ATR on Quality Control Check Repot. (Bungalows)

Block No.	(P)-	Column No.		lumn Casting (villas)	
Company	210 2 (1 2)	Project	0)	Sl. No.	30815
Prepared by	Mrw(rrb)	Sign	AUM	Phase	
Project Manager	1 con pur	Sign	Pre	Date	14/7/18
Previous stage repor	Saidhuly		Sare	Date	1417/18
Checked By MD on		30712	Report filed and	signed by PM?	Yes No
Recommendation:		MD Sign	,	For filling	Yes No

AVR Gulmohar Homes

PEDESTAL/ COLUMN

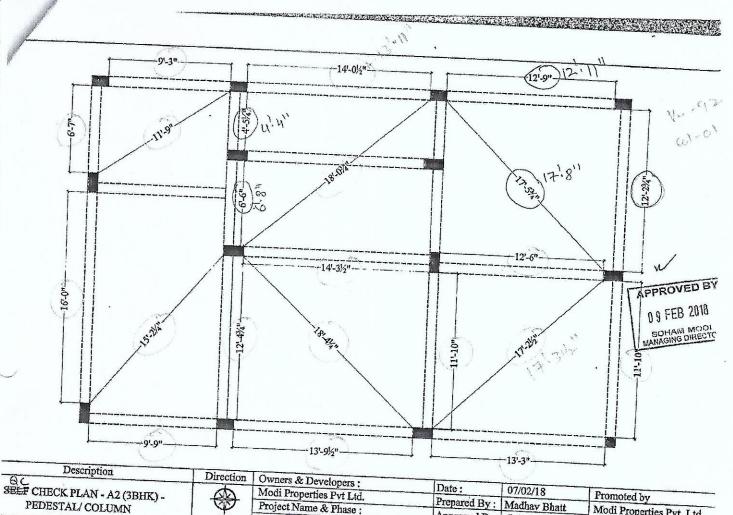
Distance of tap from furthest distance that	Yes No	
Distance of tap from furthest distance that requires curing. (max permitted 100') Frequency of curing in number of times to the control of t	36 "	
Frequency of curing in number of times a day (enquire from labourers) Is the pressure in the curing pipe more than 15' head?	2 Creek	
Quality of infrastructure for curing.	Yes No	
Remarks:	Good Avg.	Bad
Note to Celimo's put fully (evened with	anani tu	
Remarks: Note to Celump's put fully (evened with Site. Engineer Sheeraz has to make SUF-ch After Cashry plinthheams at Casple of piaces of	7 2093

3) After cashing plinthheams at Could of June	ere vertire	Yausing CC Yeguar
		Fig. 1. Annual Control of the Contro
and rolls emposing at the from	olidh bermi	€/ .
